City of Alexandria, Virginia

SUBJECT: HOFFMAN BLOCK 8 – UPDATE TO THE STAFF REPORT

Docket Item #6A-D
Hoffman Town Center – Block 8
Master Plan Amendment #2011-0005
CDD Concept Plan CDD #2011-0004
Development Special Use Permit #2011-0020
Transportation Management Plan SUP#2011-0046

Original Eisenhower Avenue Elevation

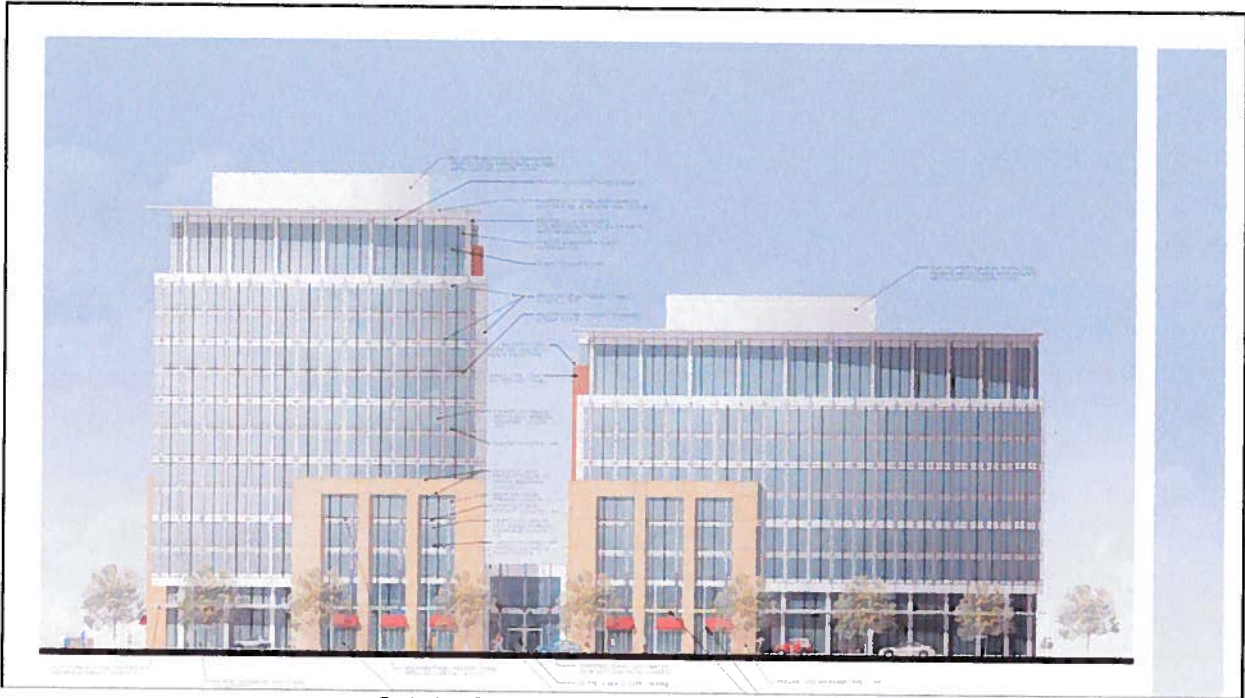
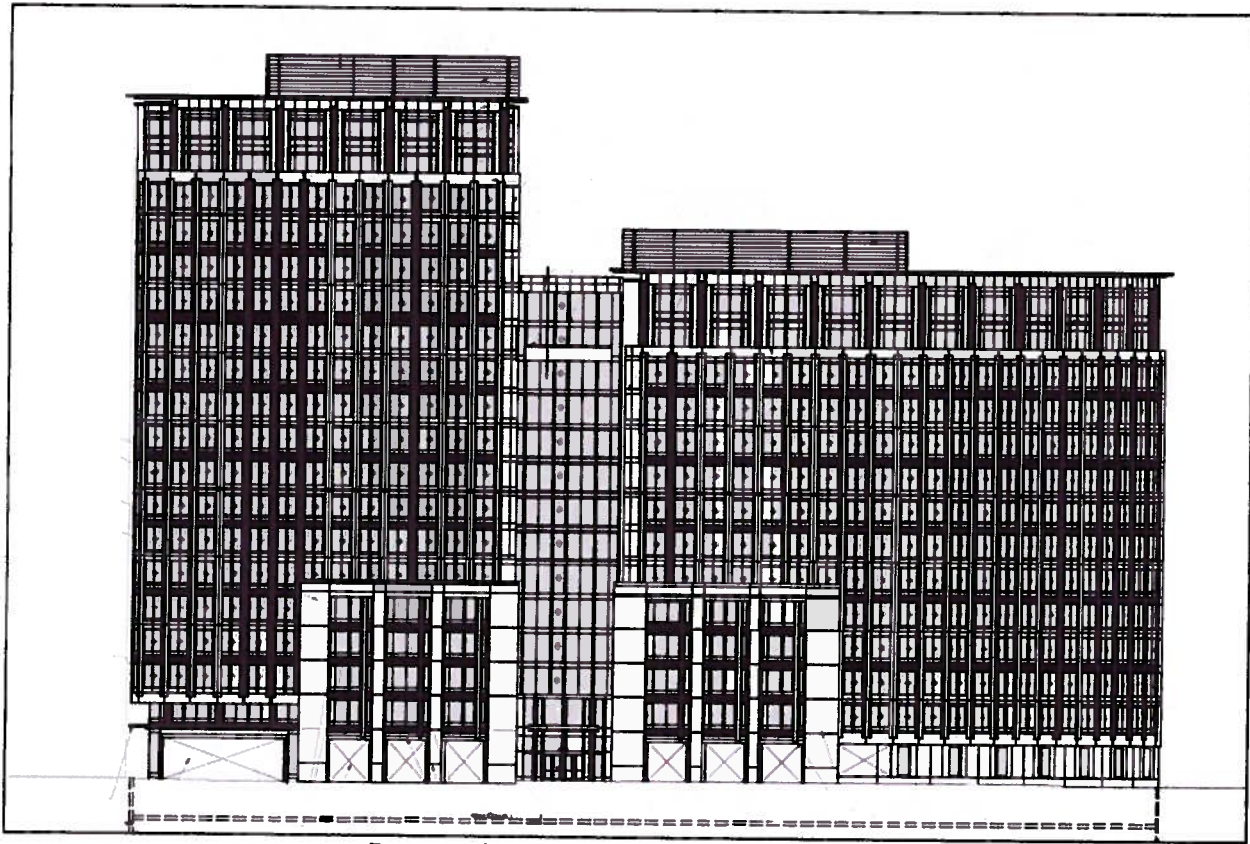
Staff also supports the vertical extension of the atrium component. With this revision, the space between the two towers would be occupied by office floor area and the floor plates between the two towers would be connected. While this does not provide the separation of the towers that occurred in the original proposal, this change is necessary to accommodate the GSA tenant since it provides the additional floor area and internal connections that the two separate towers do not. The atrium component is inset between the two towers along the Eisenhower Avenue frontage approximately 25 feet from the eastern tower and approximately 55 feet from the western tower. This recess and the designed offset of the two towers provide a visual separation. Furthermore, the applicant has proposed using spandrel glass for the stories added above the atrium in order to differentiate this recessed area from the two towers and make it more of a background element. The use of precast along the sides of the towers further delineates the extent of the towers.

When the building was first approved in 2000, the Eisenhower East Design Review Board (DRB) had not been established and the building was reviewed through the standard DSUP process. Since this DSUP constitutes a change to a building in an area that is now under the purview of the DRB, the Board reviewed the change at their meeting on June 30, 2011. As an advisory board in Eisenhower East, the Board recommended approval of the proposed revisions to the building. (see Attachment #1 for more details).
